Access Compliance Report

Public Rights-of-Way

(Curb Ramps)

Intersection ID: 29818	Main Street: WEDGEWOOD COMMONS DR	Cross Street: MINA CT	Location:	E
ADA ID: CFC03904E7D9	Ramp Type: PerpDiag	Initial Pass/Fail: Fail	Overall Compliance: No	Severity Score: 25
Codes/Mitigation Info/Possible Solution		Field Measurements/Component Compliance

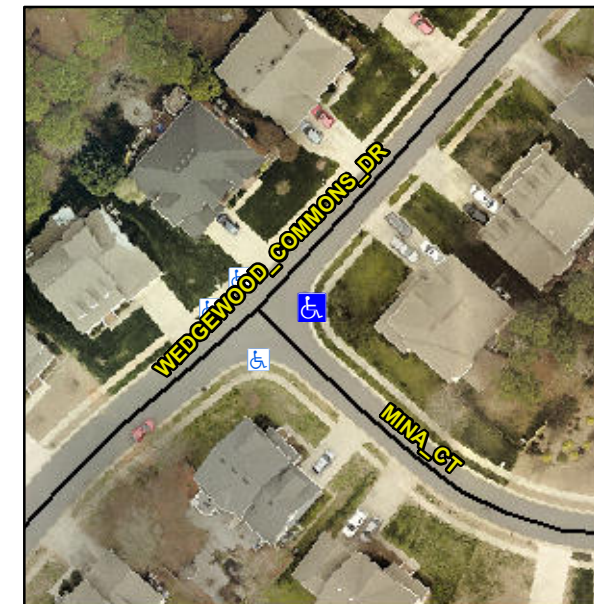
Not Found, R304.5.3

Compliance	Description	Data	Compliance	Description	Data
N/A	Ramp Length (in)	49.0	Yes	Ramp Slope (%)	5.6
Yes	Ramp Width (in)	48.0	No	Ramp XSlope (%)	10.2
N/A	Flare Type LT	N/A	N/A	Flare Type RT	N/A
N/A	Flare Slope LT (%)	N/A	N/A	Flare Slope RT (%)	N/A
N/A	Flare Traversable LT?	N/A	N/A	Flare Traversable RT?	N/A
N/A	Landing Length (in)	N/A	N/A	DWS Provided?	N/A
N/A	Landing Width (in)	N/A	N/A	DWS Contrast?	N/A
N/A	Landing Slope (%)	N/A	N/A	DWS Length (in)	N/A
N/A	Landing X Slope (%)	N/A	N/A	DWS Full Width?	N/A
N/A	Landing Curb? (Y/N)	N/A	N/A	DWS Offset (in)	N/A
N/A	Shared Landing?	N/A			
N/A	Gutter Ponding?	N/A	N/A	Gutter Slope (%)	N/A
N/A	Gutter Lip Ht (in)	N/A	N/A	Gutter X Slope (%)	N/A
N/A	Painted X Walk1?	No	N/A	Painted X Walk2?	No
	X Walk 1 Direction	To NW		X Walk 2 Direction	To SW
N/A	X Walk 1 Width (in)	N/A	N/A	X Walk 2 Width (in)	N/A
	X Walk 1 Slope (%)	4.4		X Walk 2 Slope (%)	6.5
	X Walk 1 X Slope (%)	9.0		X Walk 2 X Slope (%)	2.7

Remove & Replace Curb Ramp With Two New Directional Ramps or Equivalent.
